Submission to former Kingswood Golf Course development plan

Kingston City Council

May 2025

Development Plan Peer Review

Figure 19. Framework Plan

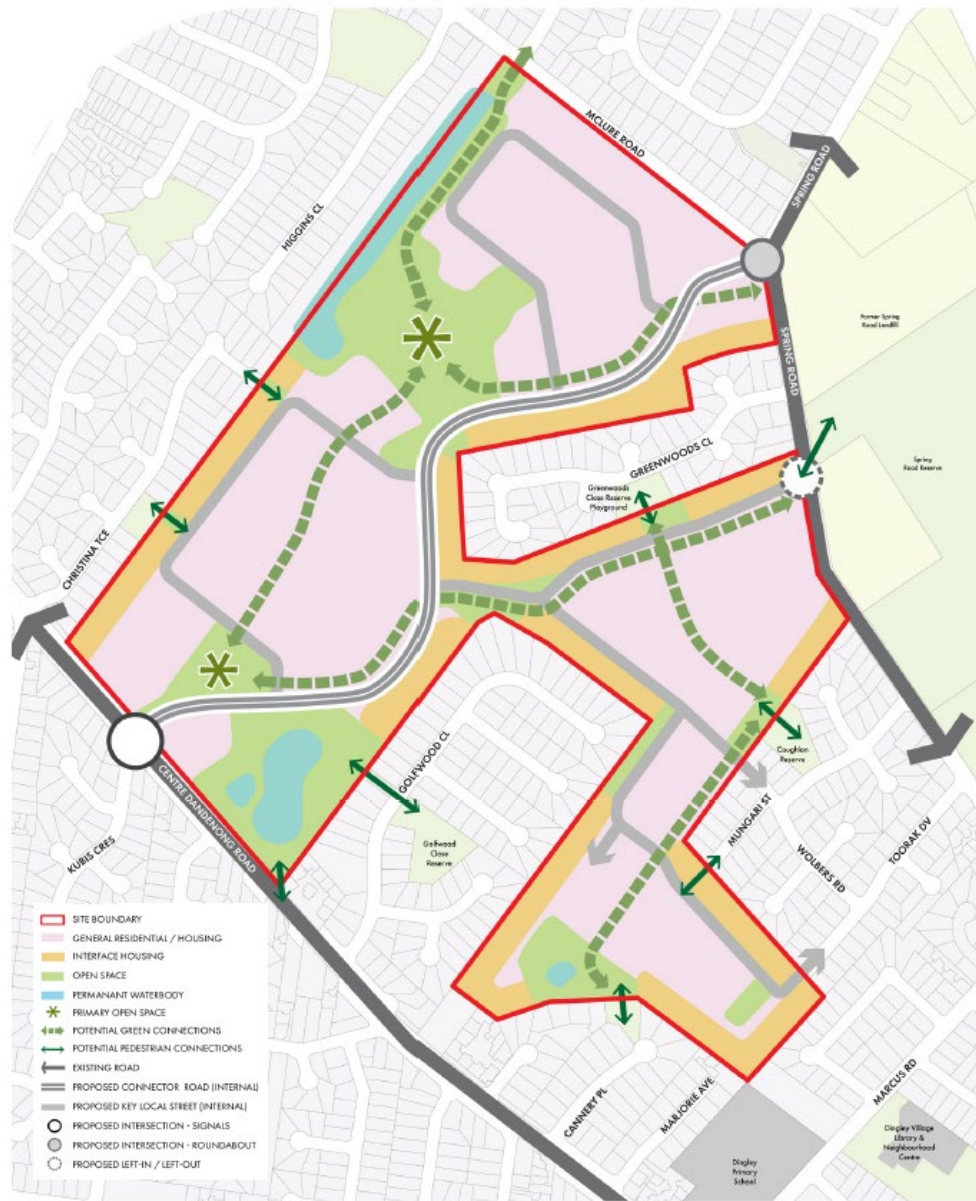
The framework plan also references 'potential green connections' and 'potential pedestrian connections.' If the role of the framework plan is to provide the overall structure for the future development of the site, it needs to provide a level of certainty around these key features of the development with more definitive language of what will be delivered.

- The Framework Plan (FP) Fig 19 which is described as '*providing the overall structure for the future development in accordance with the requirement of the DPO*' does not appear to represent the full extent of open space to achieve the minimum 20% target.

- The FP does not align with the open space allocation represented in the Landscape Concept Plan (LCP) Fig 21 or the SSP and LB which spatially represents and quantifies the minimum 20% open space allocation. Therefore, the FP represents a much lower open space allocation than the minimum 20% open space indicated in other plans.

20. Amend the framework plan to show all public open space areas that will be delivered to meet DPO8 requirements.
21. Provide clear plans that designate the areas of land contributing to the provision of open space.
22. Review the findings and recommendations in section 1 of appendix 1 to inform amendments required to the development plan.

Figure 22. Priority Environmental Values Plan

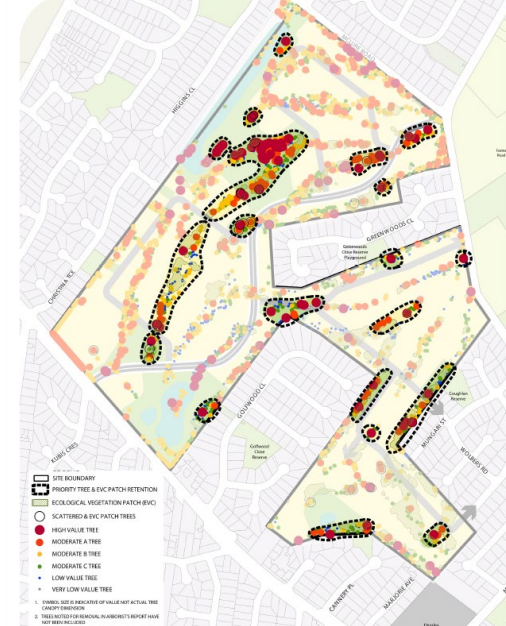
Any pedestrian and cycling connections need to consider trees being retained and how this will work with any paths proposed to be constructed. Figure 22 Priority environmental values plan shows patches of high and moderate value trees in areas adjacent to where some pedestrian connections are proposed to adjoining public open space and internal off road bike paths.

- The Priority Environmental Values Plan (PEV fig 22) indicates the areas considered a '*priority for retention, protection and enhancement*', however these priority areas are not fully protected in open space in the FP.

Figure 21. Landscape Concept Plan

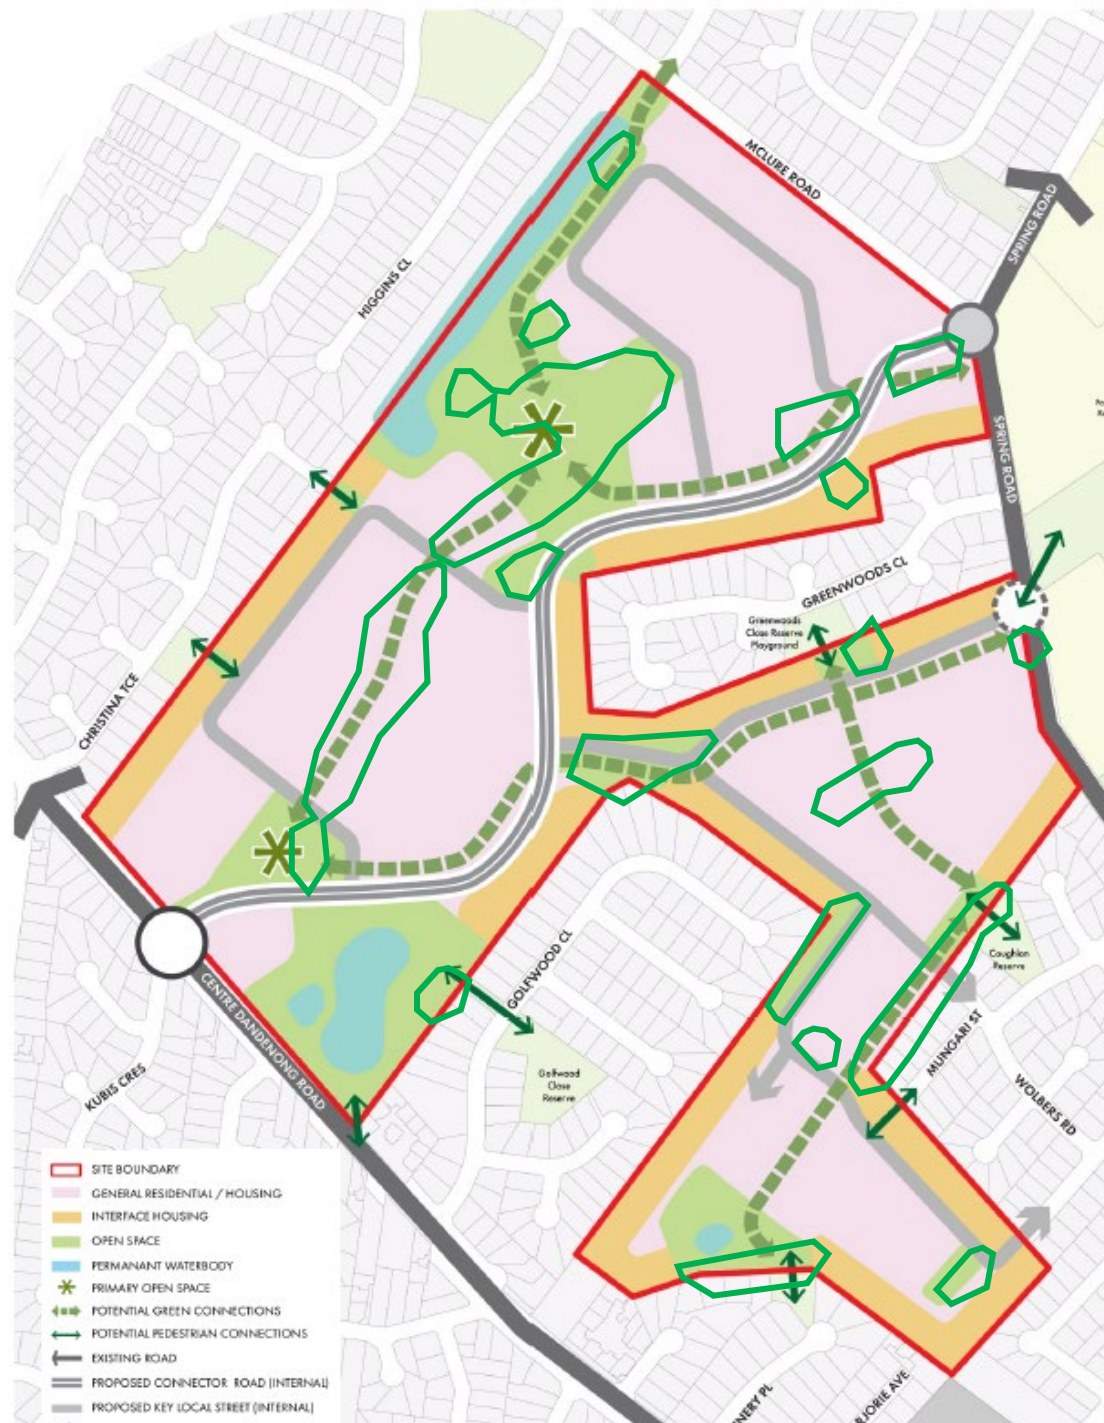
There is a landscape concept plan shown in figure 21 and a landscape masterplan shown in figure 35. The masterplan in figure 35 designates different uses for open space areas – which in a broad sense may be appropriate however the plan is not accompanied by information to explain what the intention is for each of these areas. For example, there are areas nominated for biodiversity and conversation but it's unclear if these align with priority environmental areas, what function they perform and what will be delivered in them. It is understood future subdivision applications will entail more detailed work to be considered by Council regarding the design and delivery of open spaces and infrastructure. The development plan does however need to provide a sufficient level of detail regarding open spaces, their functions and supporting infrastructure, which will commit Council to future outcomes that need to be agreed on now at this stage in the process. It's recommended in finalising the development plan, consultation is undertaken with Council's Open Space team.

- The PEV are more accurately aligned to the open space shown in the LCP (fig 21).
- There are also additional areas of open space shown in the LCP that sit outside the PEV, without explanation for the rationale for their inclusion as open space.

Figure 33. Interface and Setback Plan

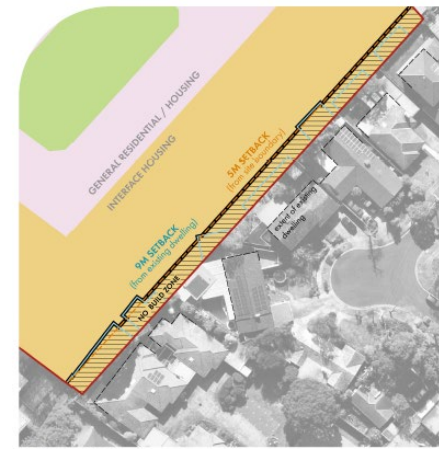
Figure 33 provides a visual example of how these minimum setbacks would be calculated on land designated as Interface Housing, where the Site adjoins existing residential development.

CURRENT PROPOSAL & SOLAR ORIENTATION

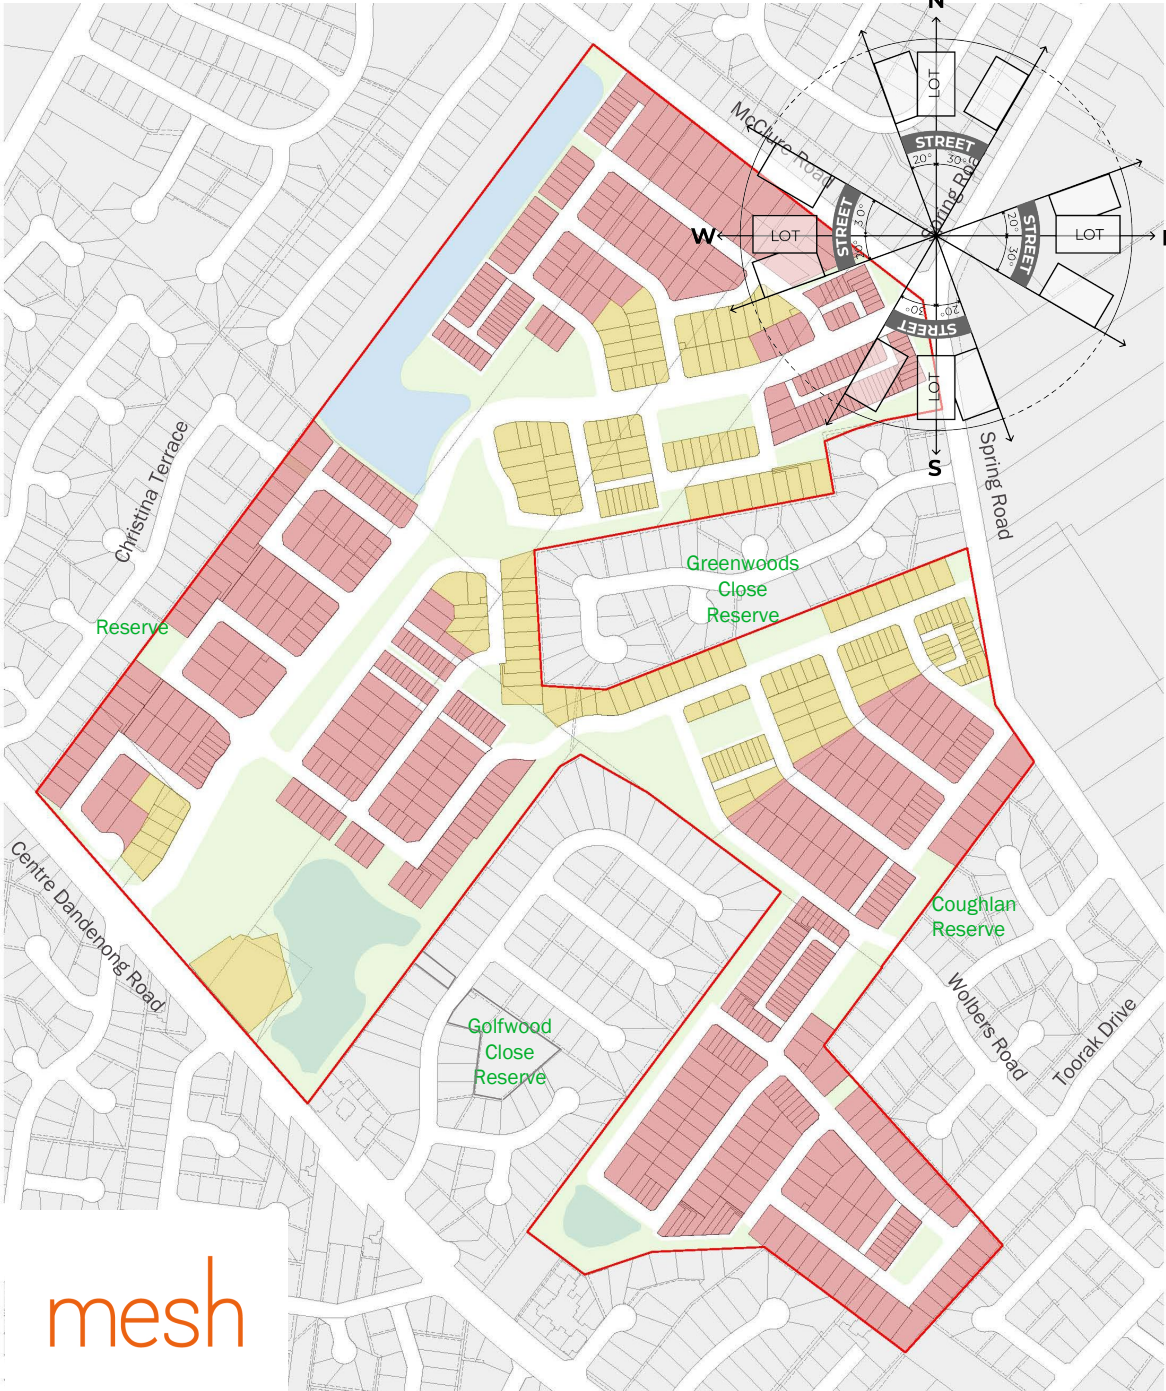
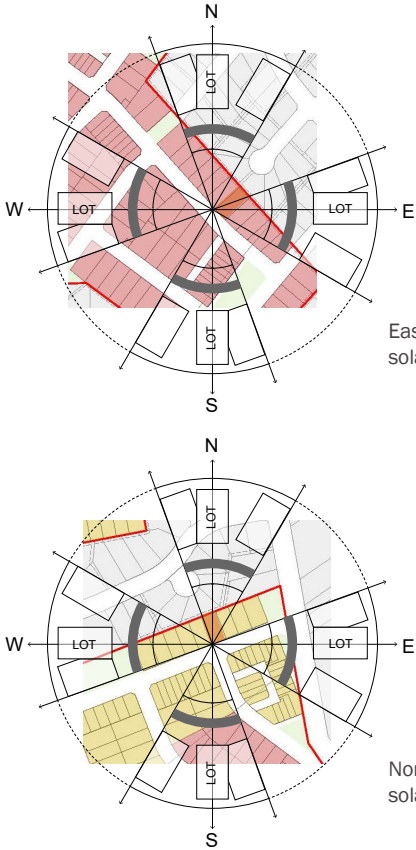
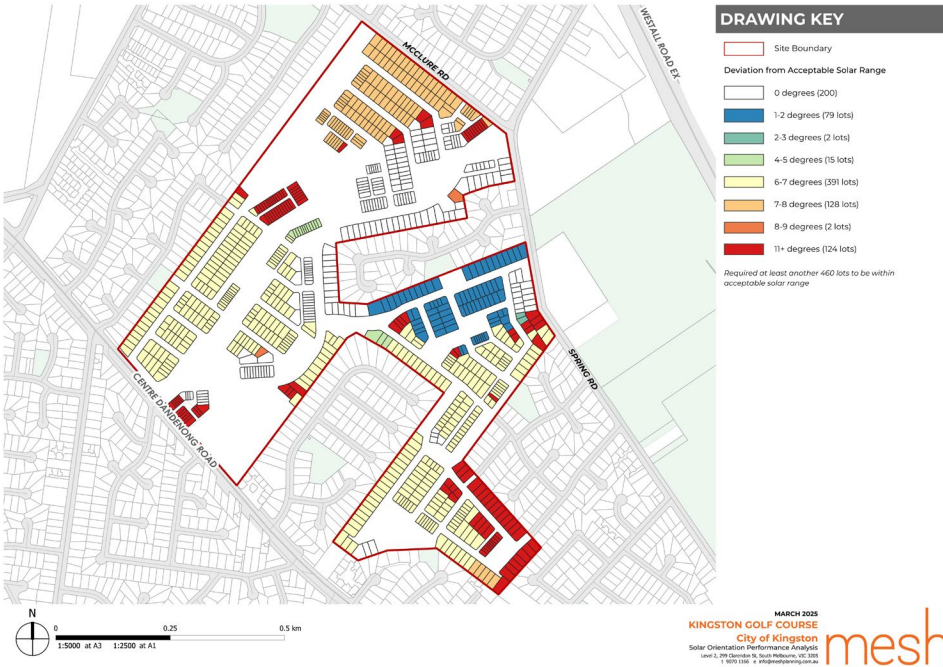
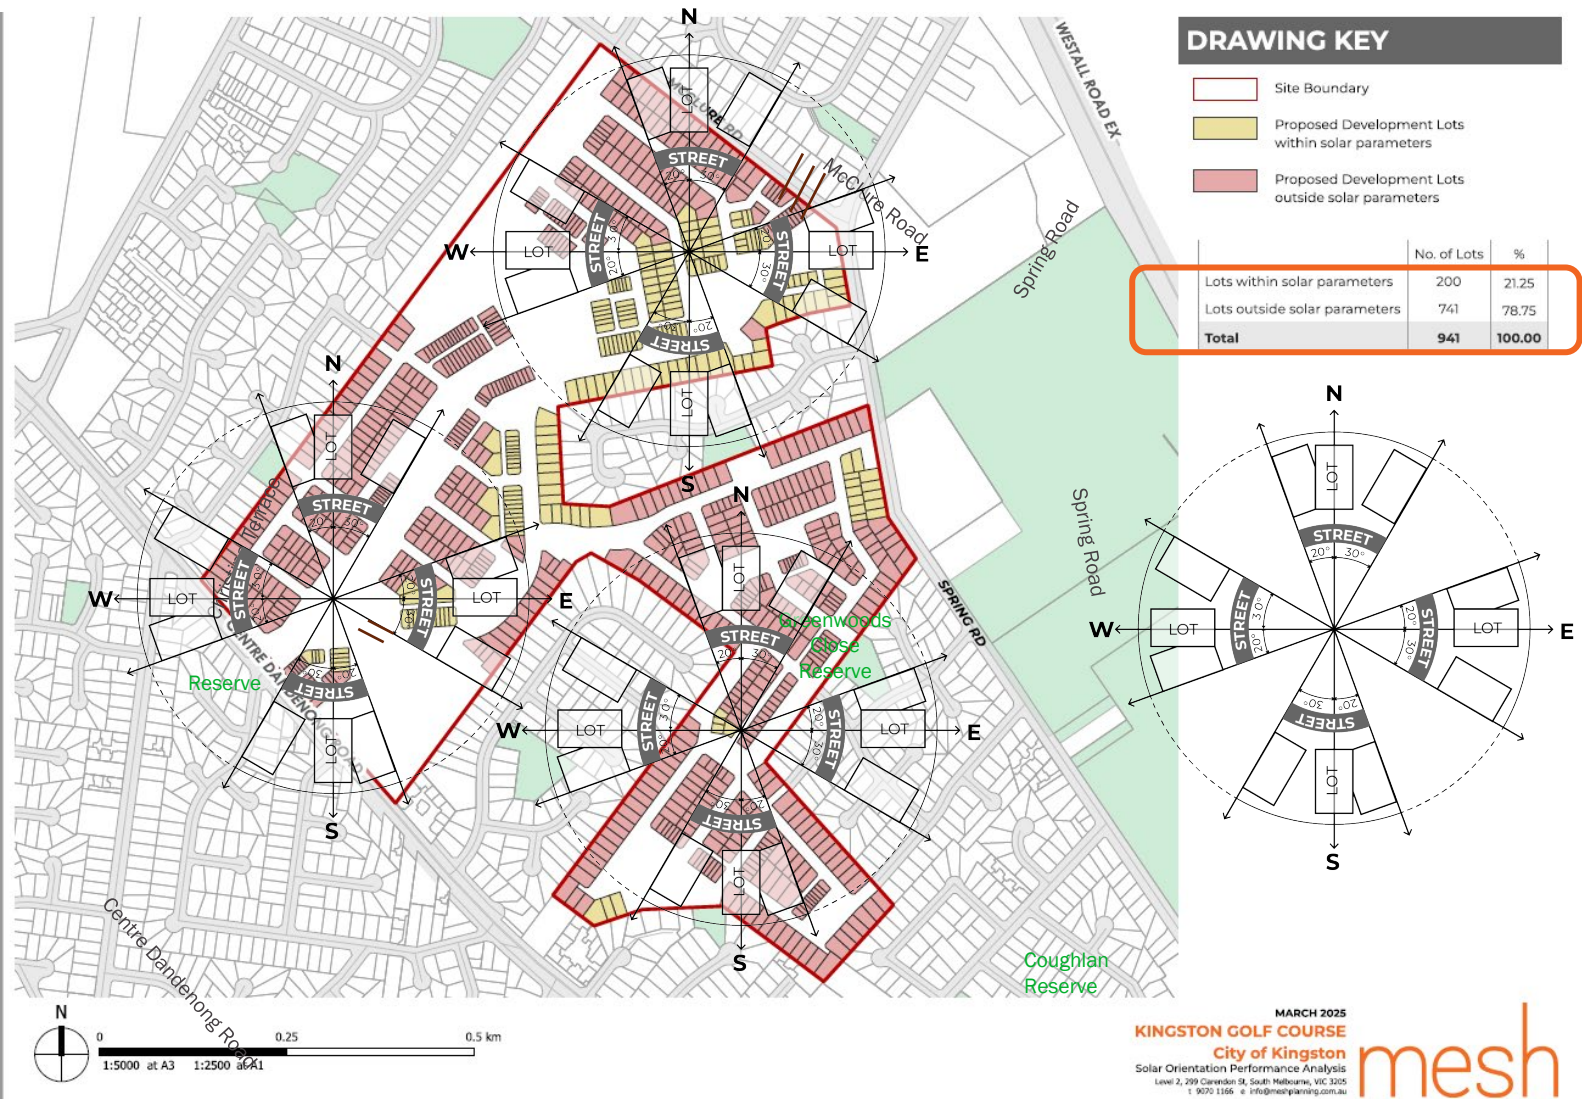
The development plan does not discuss solar orientation – a matter which will need to be addressed when a planning application is lodged for the subdivision of the site. Clause 56-04.3 of the Kingston Planning Scheme outlines the solar access standards to be applied to the subdivision. Standard C9 requires 70% of the lots should have appropriate solar orientation. Appendix 1 has assessed the subdivision concept against this standard and found approximately 21% of lots meet the solar access parameters. The assessment identifies there are opportunities to increase the number of lots that achieve appropriate orientation. It's acknowledged the site has constraints that mean it's difficult to achieve the minimum standard, however further consideration should be given to how the layout can maximise solar orientation.

KINGSWOOD SOLAR ORIENTATION PERFORMANCE ANALYSIS		
	Current Proposal	
	ha	%
TOTAL RESIDENTIAL AREA	26.8	100 %
Lots within solar parameters	7.0	26%
Lots outside solar parameters	19.8	74%

-
- a) Amendments required to supporting technical documents such as the ATC report and EHP report.
 - b) Consideration of solar access requirements in Clause 56.
 - c) Provision of the rationale behind the subdivision concept and demonstrate how the sites features and constraints have informed the plan.
9. Amend the development plan to provide more detail on the staging of key infrastructure and the rationale behind the staging phases for the site, including:
- a) Whether any temporary infrastructure or works are required to support early stages of development – for example temporary drainage basins prior to the new basins being delivered.
 - b) More information to explain how staging responds to the location and capacity of surrounding / existing services and roads, traffic volumes and movements, intersection upgrades and stormwater runoff / drainage strategy.

Figure 1c. Ecological features

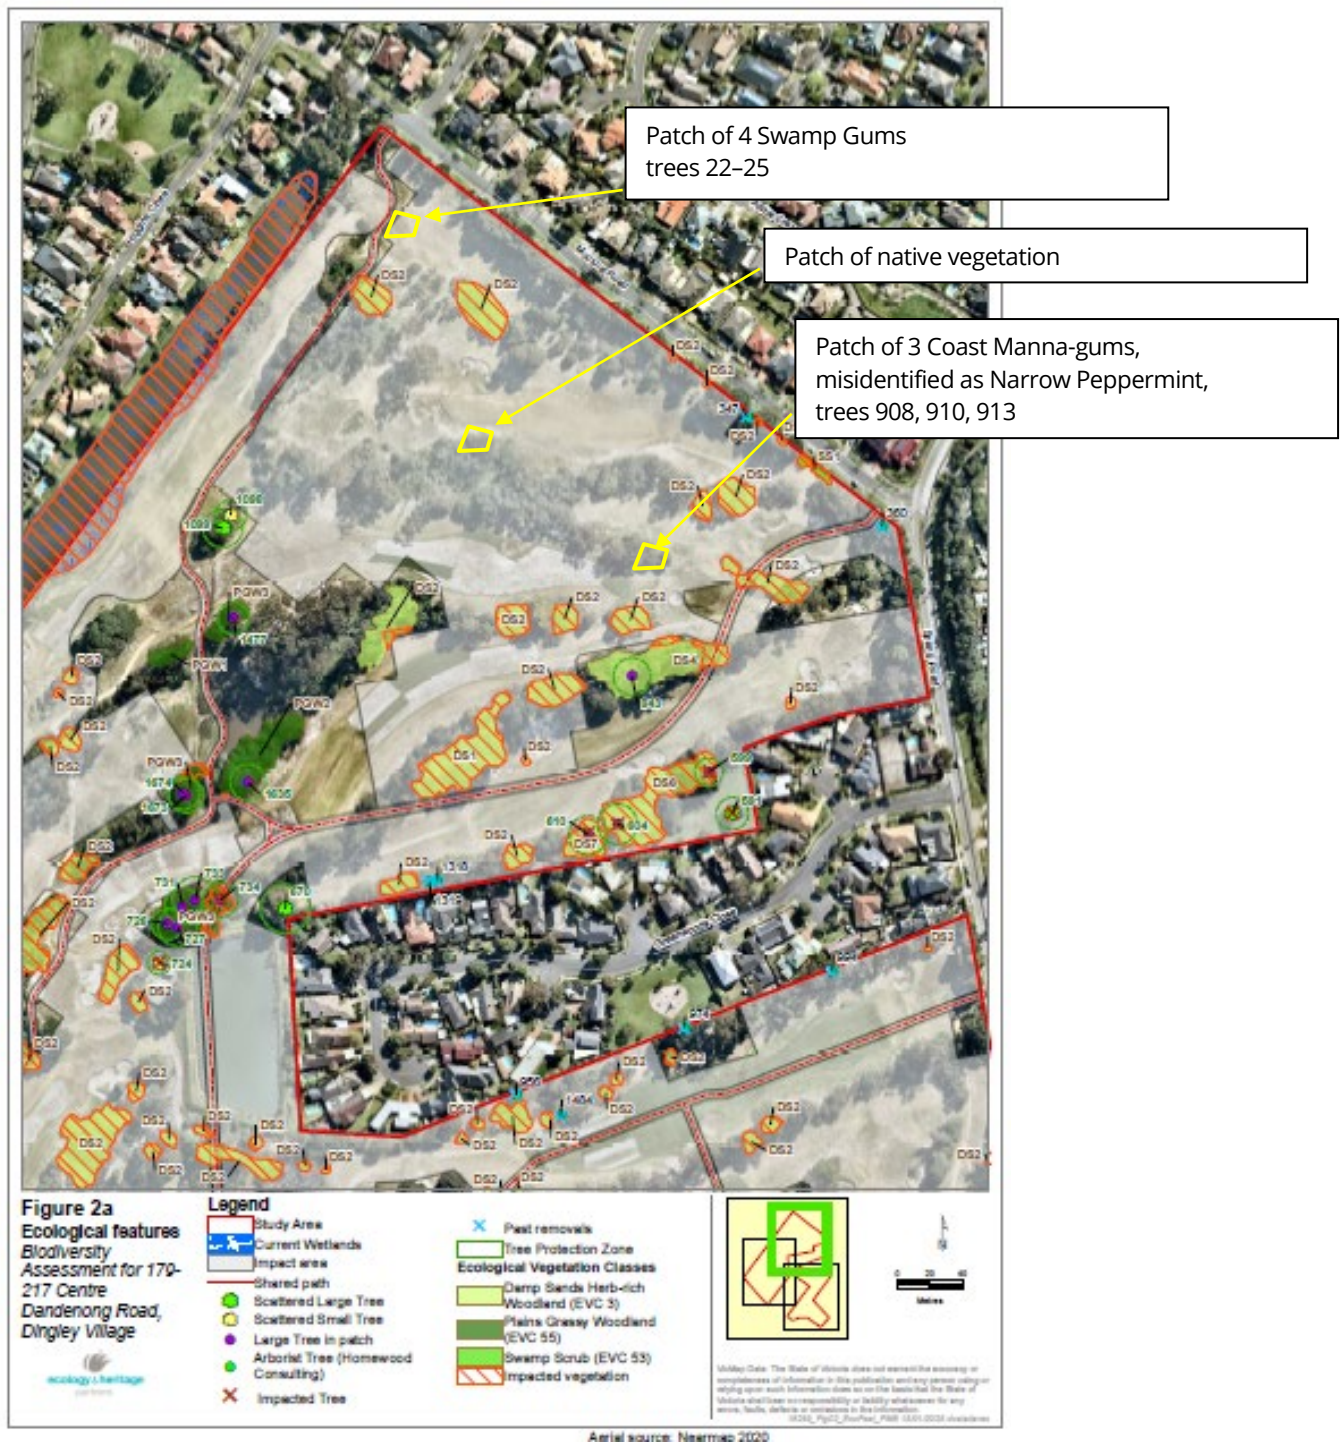
- The information on trees is confused. The tree data is from the latest arborist report (ATC Land Management 2024) but EHP cites Homewood Consulting in Figure 2 Ecological features.
- As EHP utilises ATC Land Management for tree data, issues arise.
- Numerous misidentifications were found in ATC Land Management by limited sampling:

- The EHP report may inherit identification errors from ATC as many trees misidentified by ATC are inside and outside the impact area (EHP Figure 2).
- EHP not recognising Coast Manna-gums 908, 910, 913 suggests reliance on ATC identifications to some extent. EHP may have only checked ATC identified indigenous trees, leaving out ATC exotic Narrow Peppermint, Brown Stringybark and Blue Box of which many are Coast Manna-gum.

4. Amend the Ecological Assessment to clarify which tree data it is relying upon, and all trees/vegetation are appropriately identified and calculated, along with any consequential changes to the native vegetation calculations and required offsets.
